## ENGAGEMENT SUMMARY

# SPRINGBANK PARK ESTATES + ROYAL SPRING ESTATES

Date: February 1, 2021

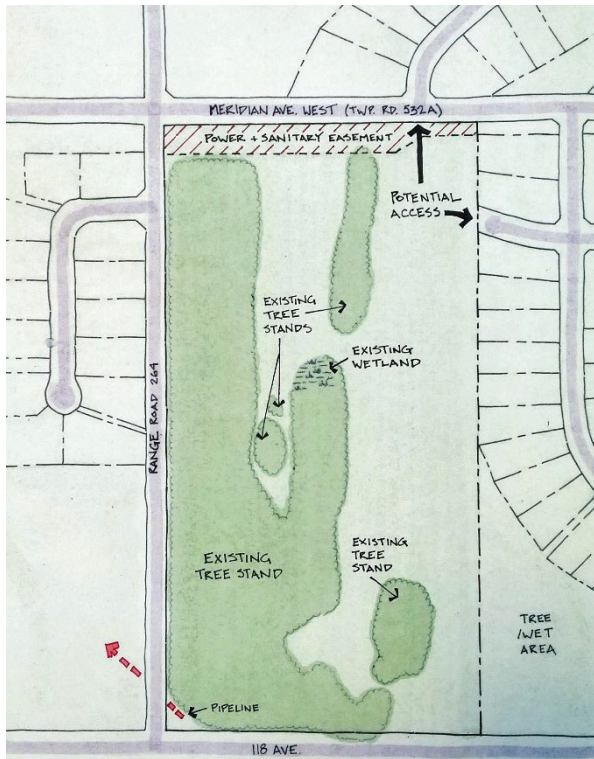
I generally like the concept, especially how the layout works around the existing vegetation to maximize tree preservation.

The only question I have is regarding the existing wet land in the middle of the site and how is it going to drain?

The proposed road and residential lots are going to obstruct the natural surface drainage pattern. I am assuming a culvert would be installed at the road so drainage can flow under the road, but then for the surface drainage to get to the constructed wetland, it would have to flow through the residential lots or follow road ditches the long way around and against the existing topography.

Utilizing the existing topography and LID approach, the concept could consider a long linear wetland drainage feature (rain garden, bioswale), connecting the existing wetland to the low part of the site, instead of the typical large constructed wetland.

I wonder if future residents would prefer a larger and longer noise attenuation berm along the highway? The negative would be the need to remove much of the existing vegetation screen along the south end of the project site.

Further assessment of the existing tree stand for age and health should be undertaken so the design and client team can weigh the pros and cons of the existing tree removal in place of a vegetated noise attenuation berm.
